WOLF CREEK

May 2, 2007

ET 07-0011

Subject: Docket No. 50-482: Response to NRC Requests for Additional Information Related to Wolf Creek Generating Station License Renewal Application

USAR FIG. 9-2-17-02

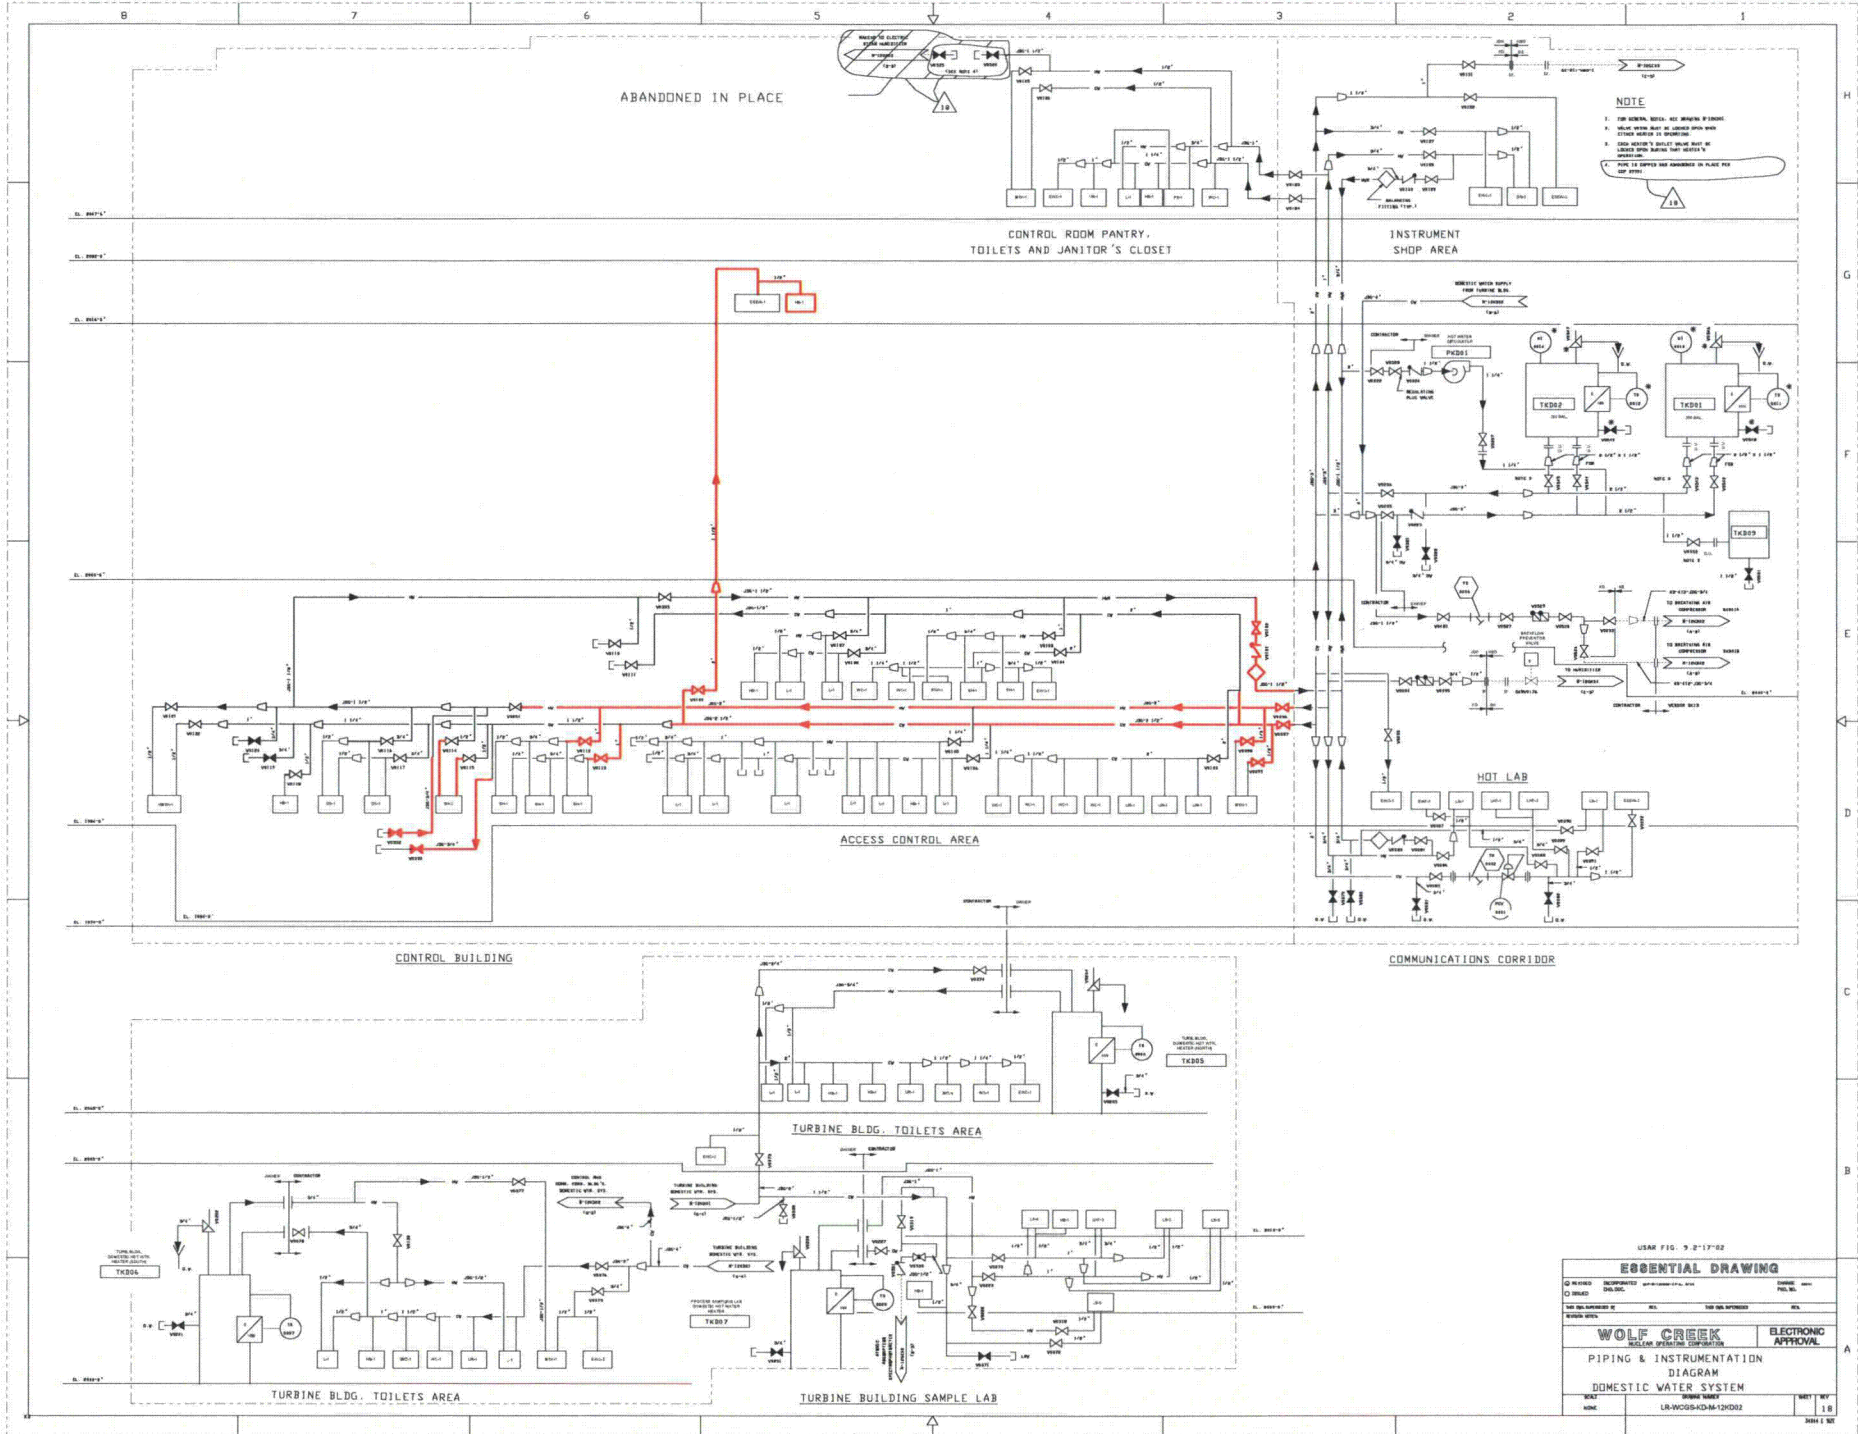
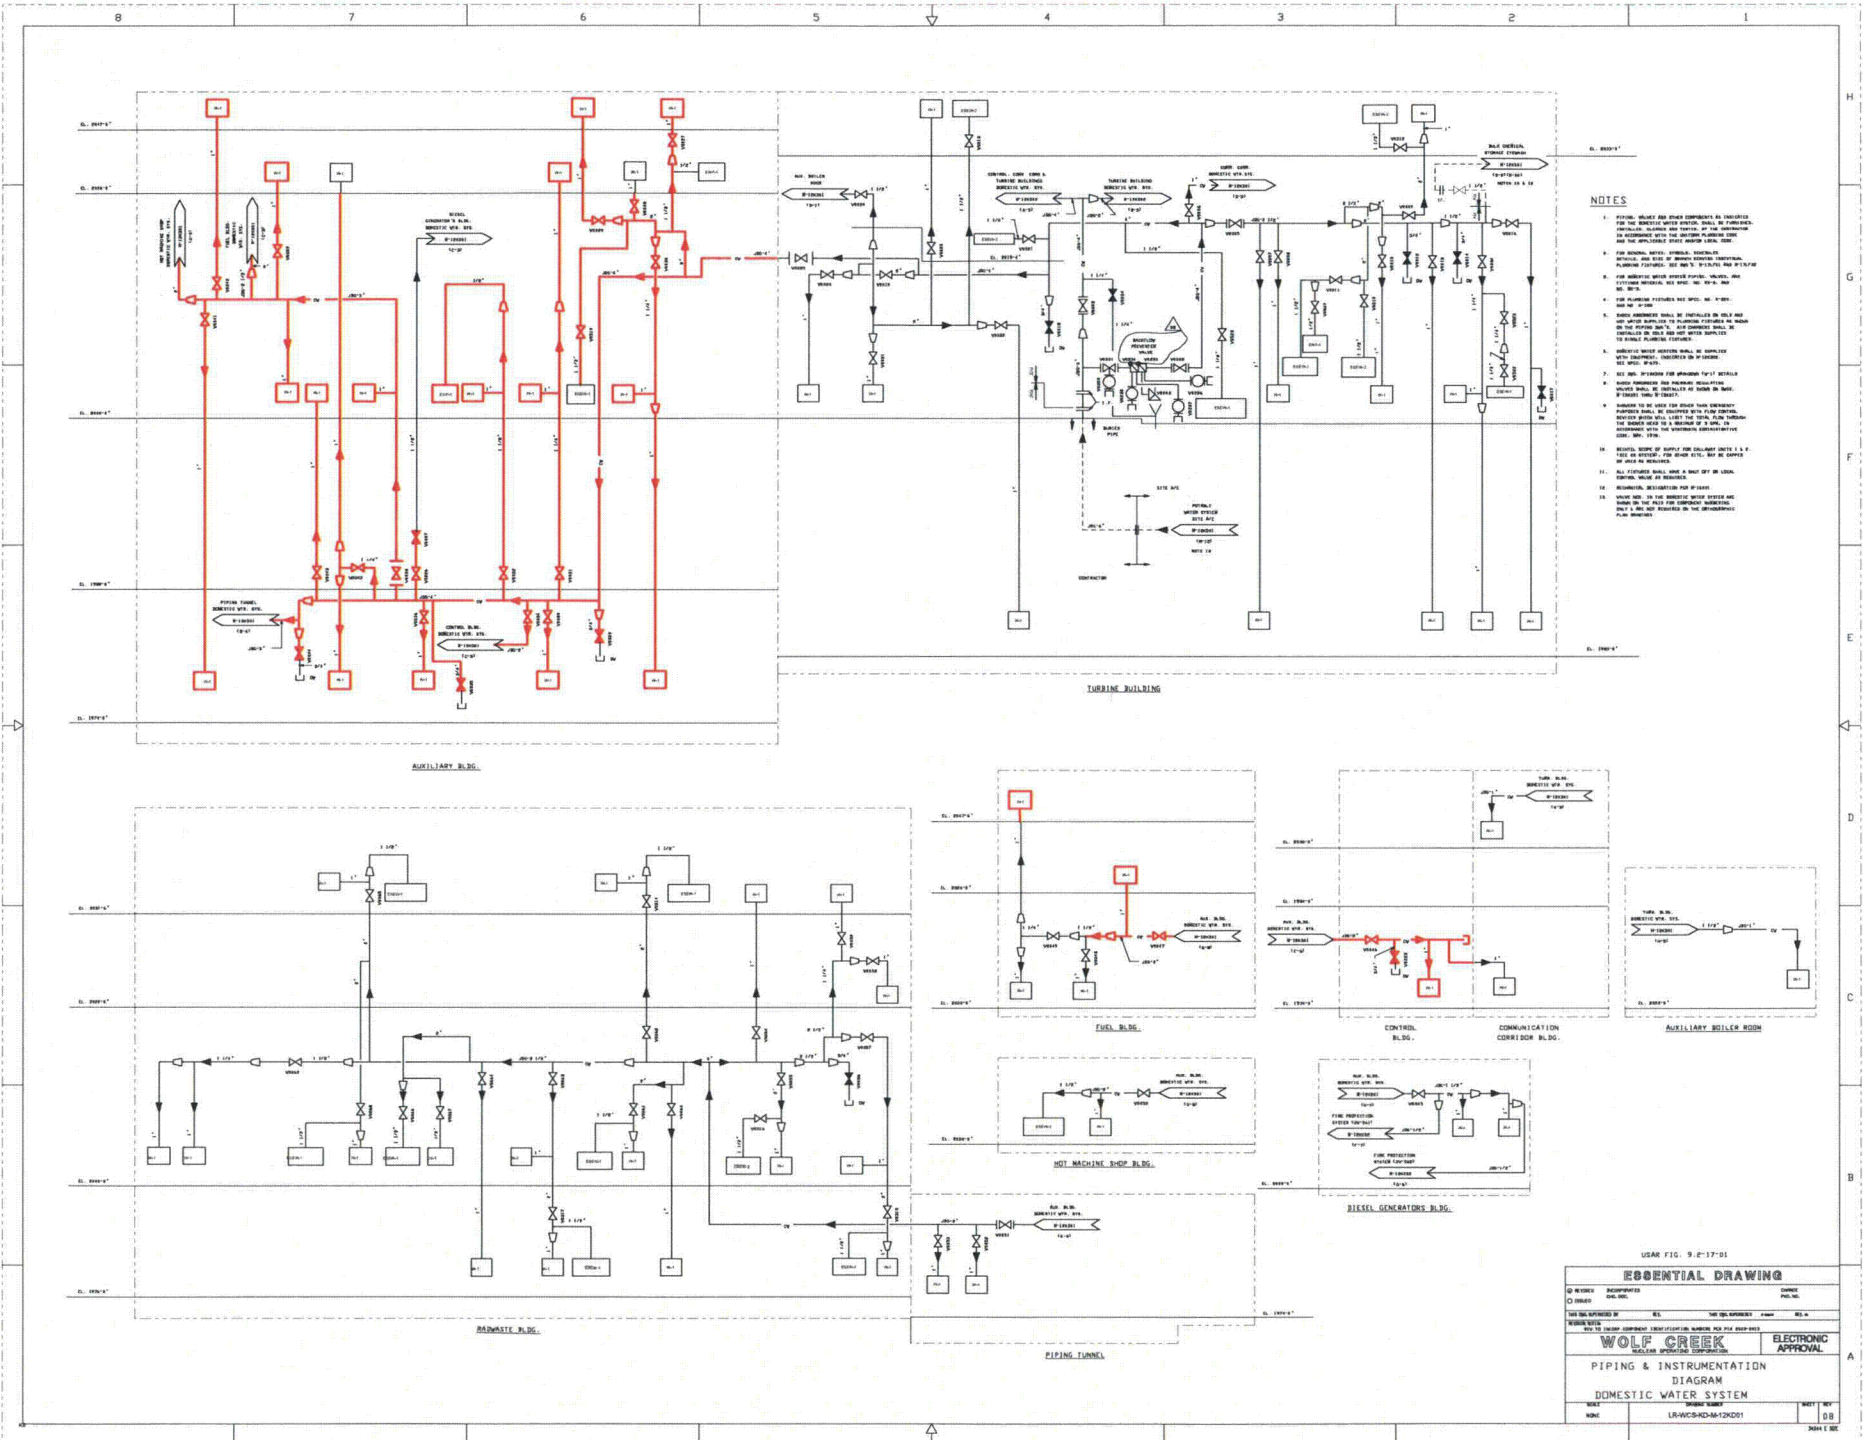
- (4) License renewal drawings LR-WCGS-KD-M-12KD01 and LR-WCGS-KD-M-12KD02, for the domestic water system, show system portions highlighted in red and ending with no further explanation. The staff requests that the applicant provide a description of the portions of the domestic water system that are within the scope of license renewal for meeting the requirements of 10 CFR 54.4(a)(2) due to spatial interaction. In addition, the staff requests that the applicant discuss the reason for terminating the scoping boundaries where indicated.

As shown on license renewal drawing LR-WCGS-KD-M-12KD01 and LR-WCGS-KD-M-12KD02 domestic water system components are in the scope of license renewal for meeting the requirements of 10 CFR 54.4(a)(2) due to spatial interaction. Fluid filled domestic water system components have spatial interaction with safety related components in the auxiliary building, the control building and the fuel building.

Domestic water system boundary drawings LR-WCGS-KD-M12KD01 and LR-WCGS-KD-M-12KD02 have been revised to clarify domestic water component spatial interaction ends points. The revised drawings are provided in Enclosure 1.
